**OHIO RIVER BRIDGES
SECTION 2 - DOWNTOWN BRIDGE
VALUE ENGINEERING STUDY REPORT**

Item Number 5-118.00

**Study Date: February 18 - 22, 2008
Report Date: March 7, 2008**

URS conducted a Value Engineering Study of the Louisville-Southern Indiana Ohio River Bridges, Section 2 – Downtown Bridge project. The topic was the 15% Design Development Submission prepared for the Kentucky Transportation Cabinet (KYTC) by Michael Baker, Jr., Inc.

Shape of towers with triangular edge requires custom forming full height; simplify tower cross section.

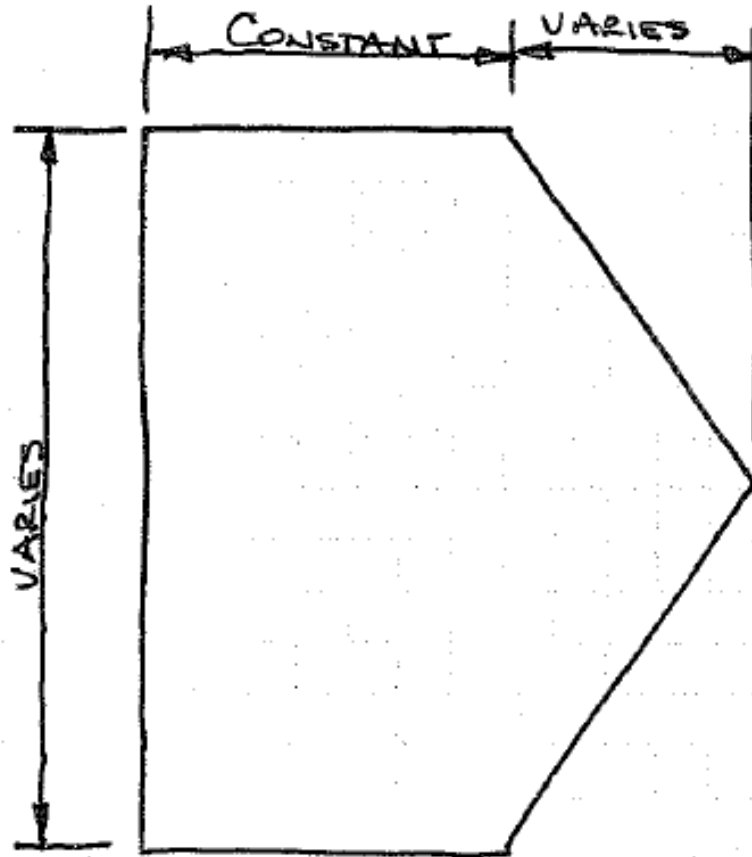
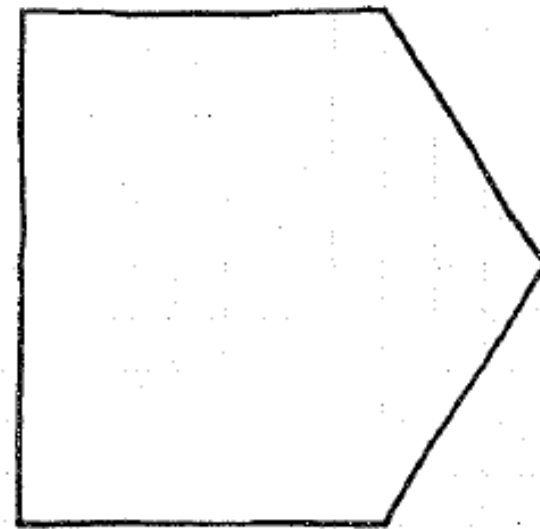
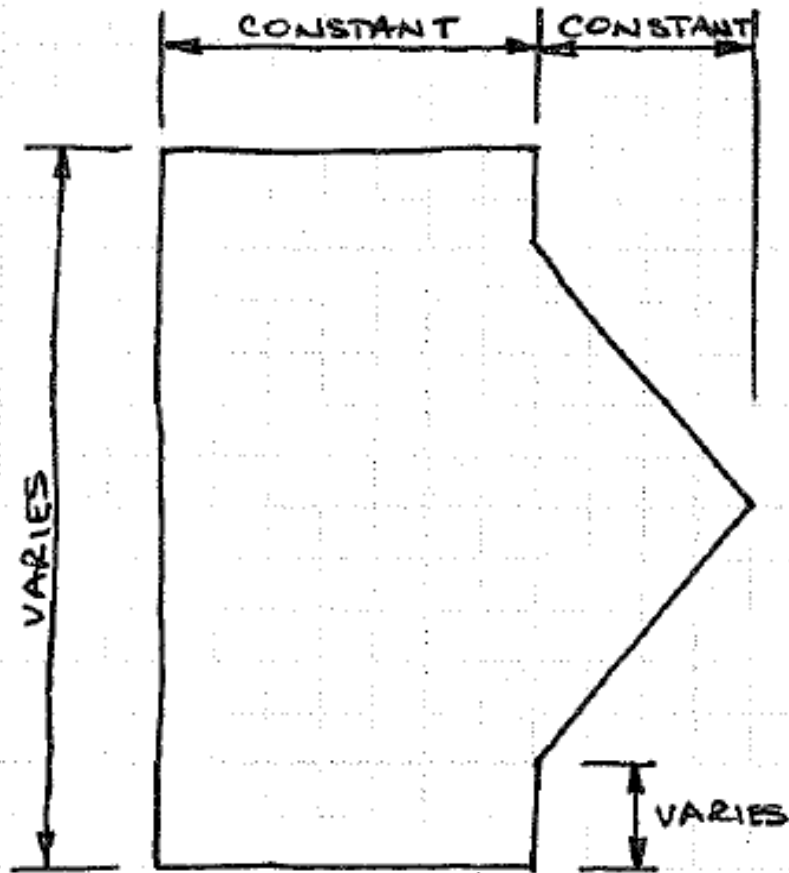
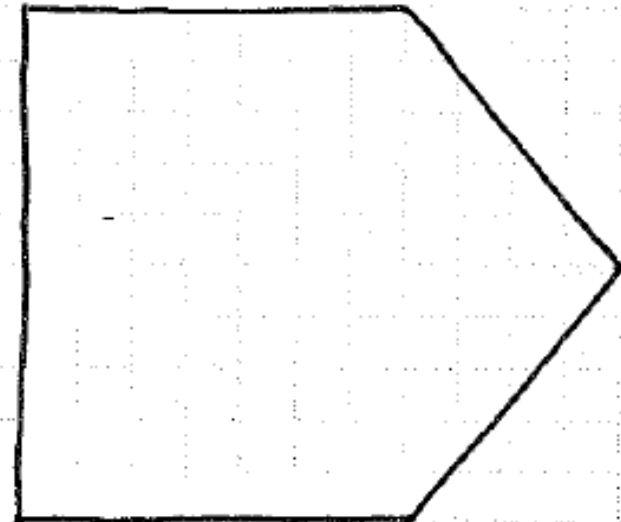
The text in the Bridge Type Selection Report for the four span cable stayed bridge states that the tower cross section will be comprised of a rectangular base with a triangular nose on the outside faces. With this triangular nose, it is necessary for the section to taper in both the depth and transverse width of the leg.

While this triangular nose on the tower legs may create an interesting look, it will require customized forming for the full height of the tower. Consideration should be given to modifying the triangular nose so that a reasonable forming system can be developed for the towers.

Utilize 4 foot shoulders in lieu of 12 foot shoulders on the new I-65 NB Bridge.

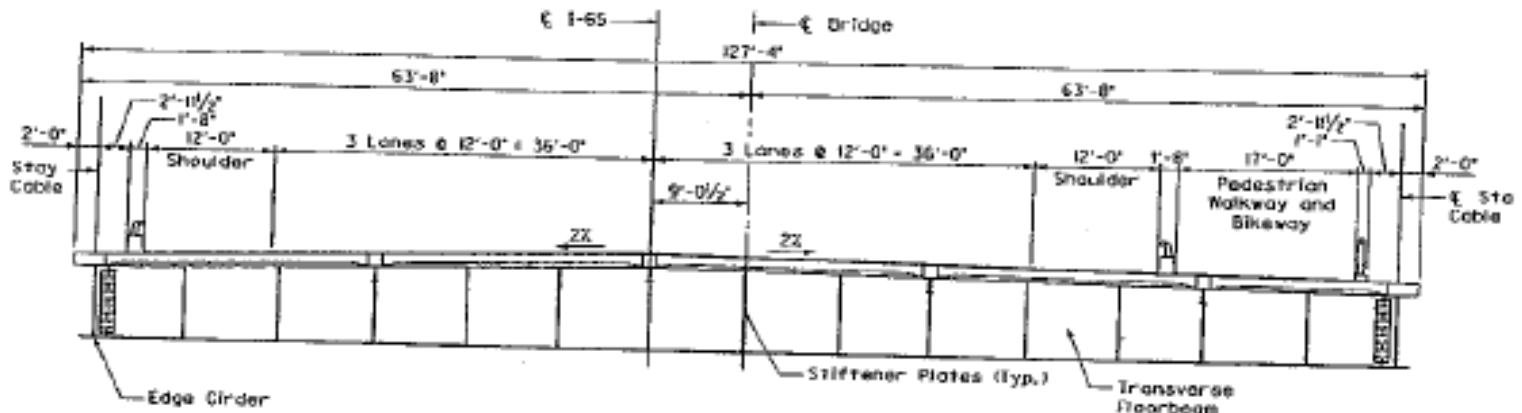
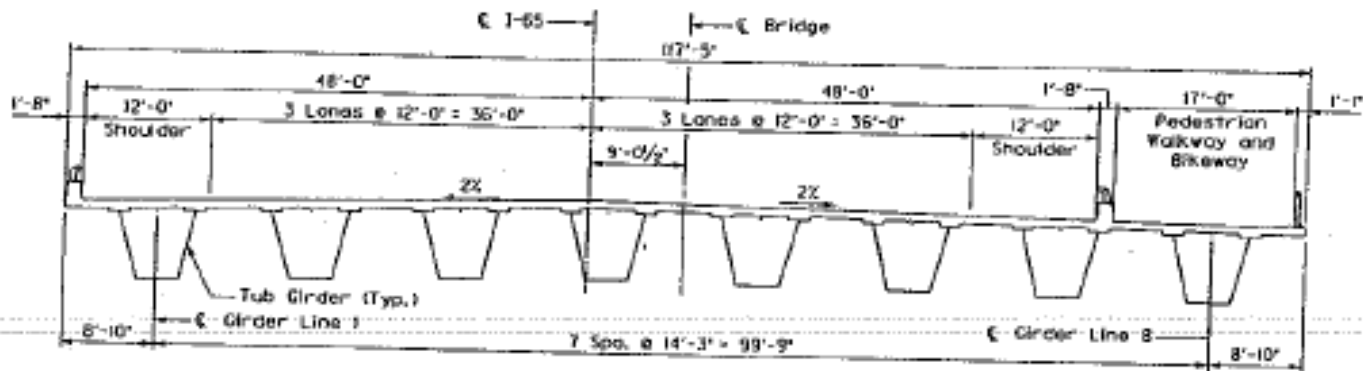
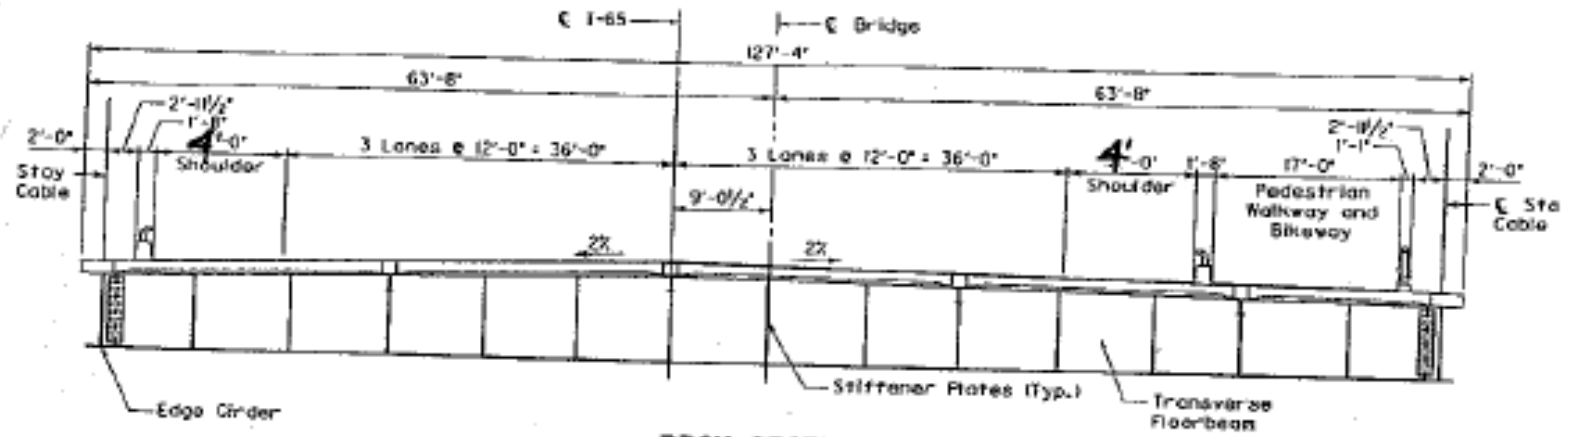
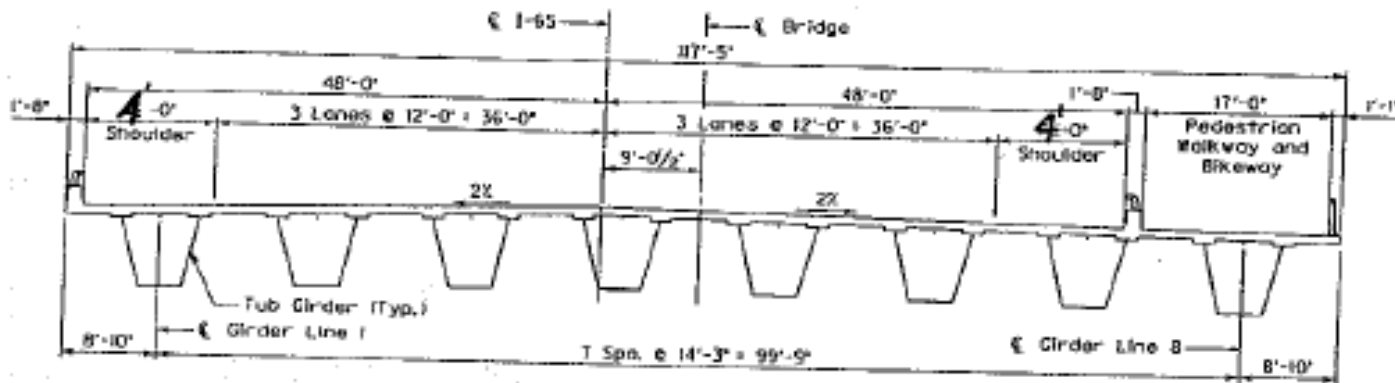
The original design includes 12 foot shoulders across the new I-65 NB Bridge across the Ohio River. The 12' shoulder is the desirable shoulder width in the January 2005 AASHTO Policy on Design Standards on the Interstate System.

The recommended change calls for the reduction of the 12 foot shoulder width to 4 foot. The same AASHTO guide (January 2005 AASHTO Policy on Design Standards on the Interstate System) on page 5 states that 4 foot is allowable on long bridges greater than 200 foot in length. The new I-65 bridge is 3300 foot long.

Given the cost of this megaproject (\$4.1 billion) and the increased scrutiny by the public, every effort should be made to control costs. Given that 4 foot shoulders are within current AASHTO guidelines, a modification to this width is reasonable to recommend.

**Alternative #2
(Preferred)**

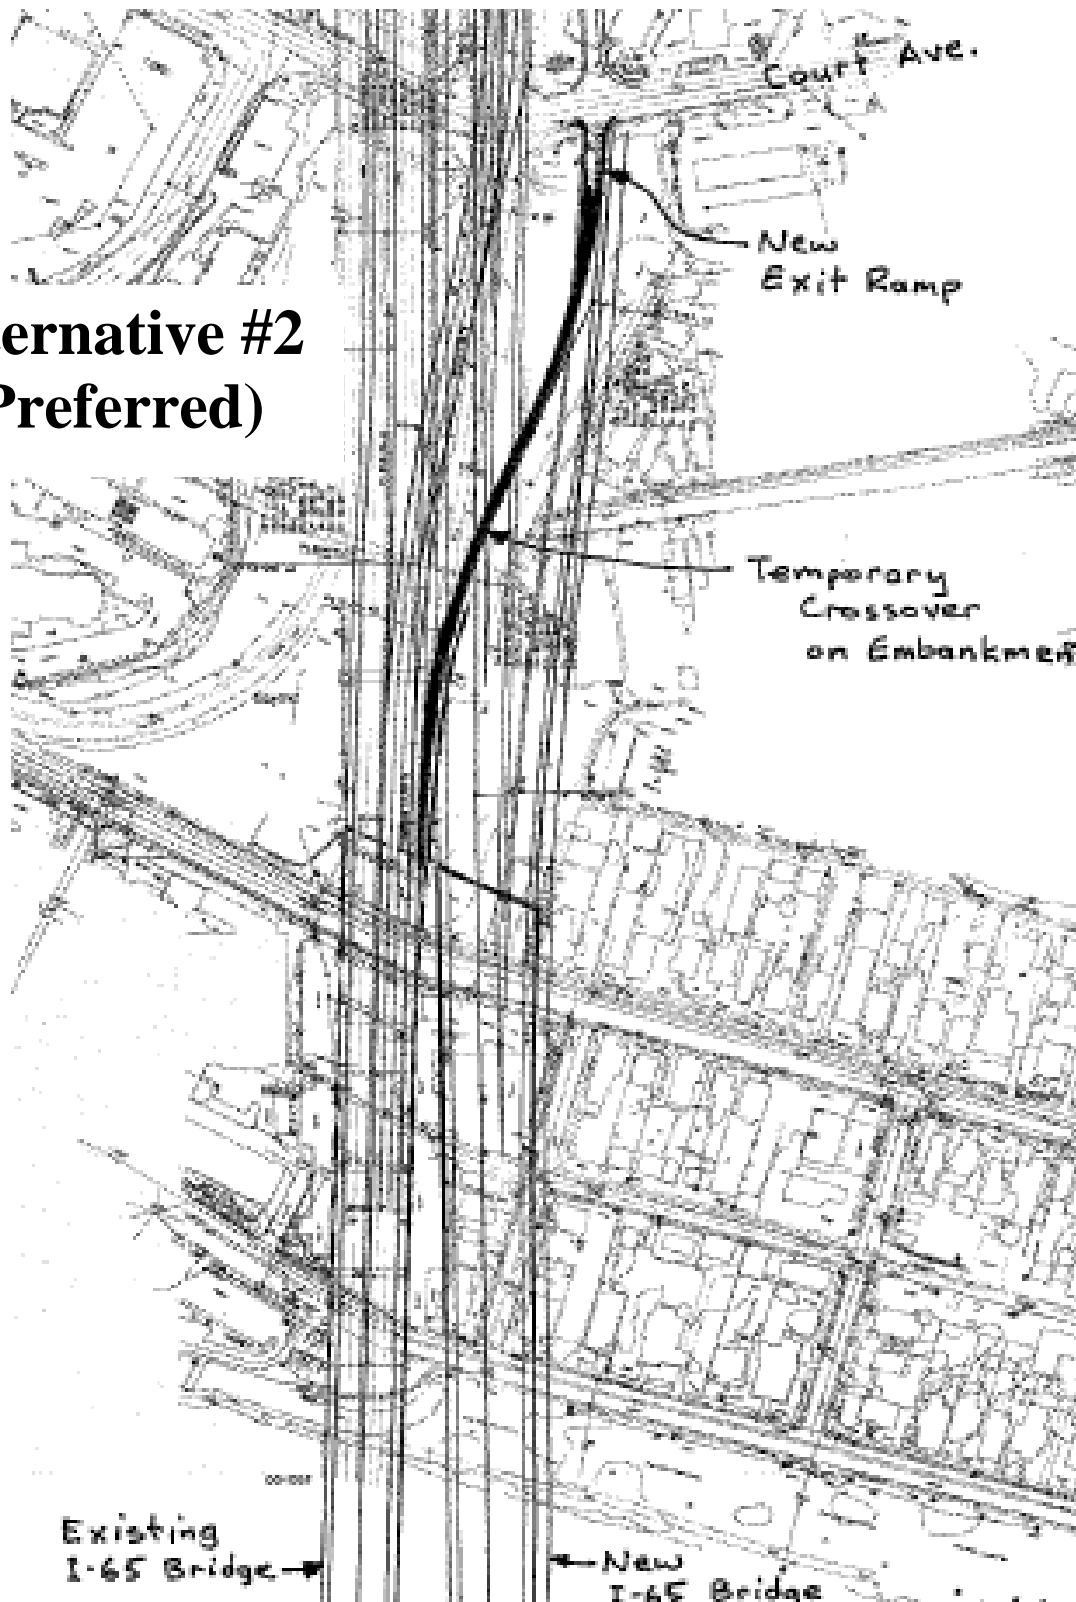
The study examined two alternatives, both of which placed the I-65 mainline crossover on the embankment. Alternative 1 utilized a crossover bridge to shift the Court Avenue exit traffic to the new location near the new exit gore area and had a preliminary construction cost estimate of \$2.5 million. Alternative 2 utilized a crossover on the embankment to shift the exit traffic to the new location near the end of the new ramp and had a preliminary construction cost estimate of \$1.75 million. Each alternative has its own advantages.

It is noted that Alternative 1 would require that the new I-65 Indiana bridge approach spans be completed prior to implementation of this phase, or would not be completed until later using part-width construction. Therefore, Alternative 2 is recommended by the VE team.
